Aeronautical Study No.  
 2007-AWP-7319-OE  
 Prior Study No.  
 2007-AWP-6411-OE

**\*\* DETERMINATION OF NO HAZARD TO AIR NAVIGATION \*\***

Structure: Stack HRSG Stack #1  
 Location: Victorville, CA  
 Latitude: 34-37-57.25N NAD 83  
 Longitude: 117-22-16.68W  
 Heights: 145 feet above ground level (AGL)  
 2945 feet above mean sea level (AMSL)

**FAA DETERMINATION OF NO HAZARD TO AIR NAVIGATION FOR STACKS  
HRSG #1 AND #2**

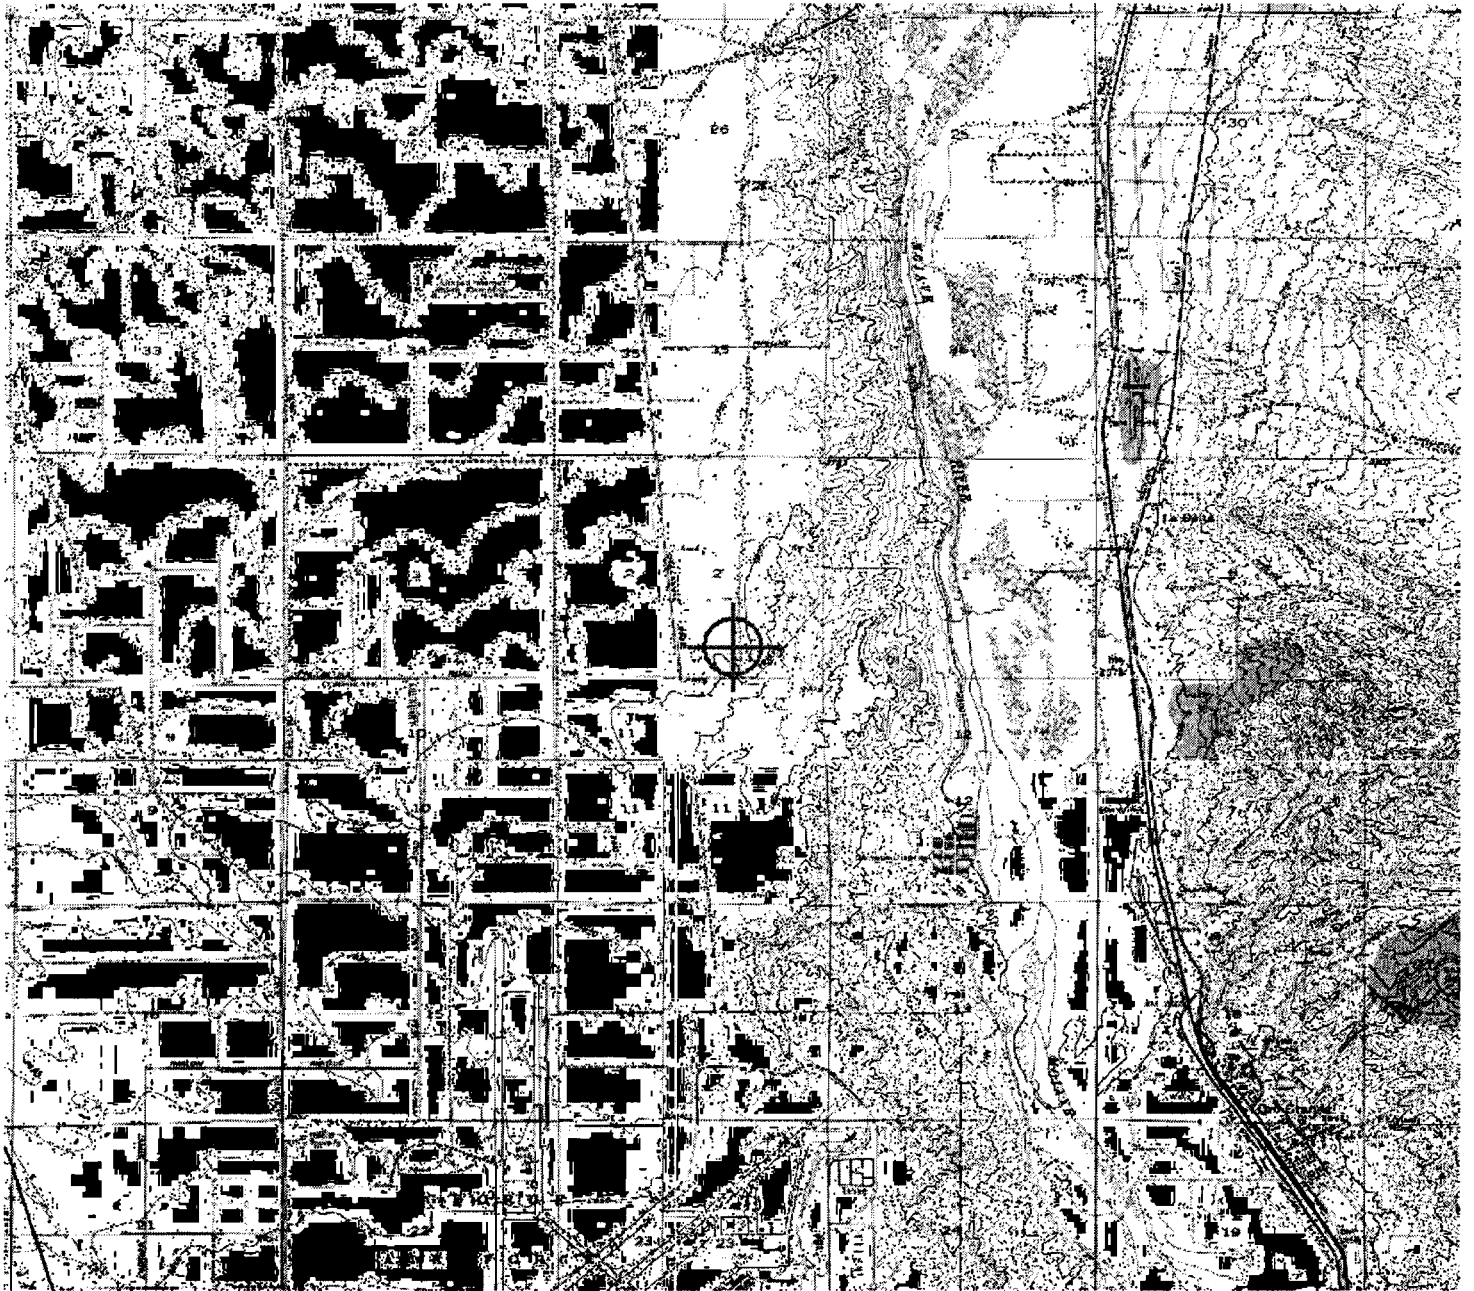
FAA evaluation of two components of the proposed power generating facility, Heat Recovery Steam Generator Stack #1 and Stack #2 found that their proposed heights would be identified as obstructions under the standards of Federal Aviation Regulation (FAR) Part 77, Subpart C, as applied to the (VCV) airport:

Section 77.23(a)(3), a height that increases a minimum instrument flight altitude within a terminal area (TERPS criteria); would increase the GPS Rwy 17 minimum descent altitude (MDA) from 3140'amsl to 3220'amsl; and, would increase the VOR/DME Rwy 17 (MDA) from 3200'amsl to 3260'amsl. No other instrument procedures would be affected.

Stack #1 is 145'agl/2,945'amsl and is located 6,124 feet from the (VCV) Runway 17 physical approach end.

Stack #2 is 145'agl/2,945'amsl and is located 6,223 feet from the (VCV) Runway 17 physical approach end.

Although the planned increase in the Minimum Flight Altitudes for the (VCV) GPS Rwy 17 and VOR/DME Rwy 17 instrument approaches would not cause a significant change in the usability of the procedures, continued cumulative erosion of the (VCV) published (MDA), in order to facilitate non-aeronautical development and construction is not encouraged.

Until the GPS Rwy 17 and VOR/DME Rwy 17 (MDA) have been amended, Stack #1 shall not be constructed to a height above 2,929'amsl with a certified 2C-accuracy survey, and Stack #2 shall not be constructed to a height above 2,937'amsl with a certified 2C-accuracy survey.

The ultimate final maximum heights of Stack #1 and Stack #2 shall include all top-mounted appurtenances, including but not limited to; obstruction lighting and external rim equipment.

Stack #1 and Stack #2 shall be dual-lighted with white medium intensity strobe lighting for day and red obstruction lighting between sunset and sunrise, in accordance with the provisions of FAA Advisory Circular (AC) 70/7460-1, "Obstruction Marking and Lighting." This AC can be downloaded from the public web site [www.oiaaa.faa.gov](http://www.oiaaa.faa.gov).
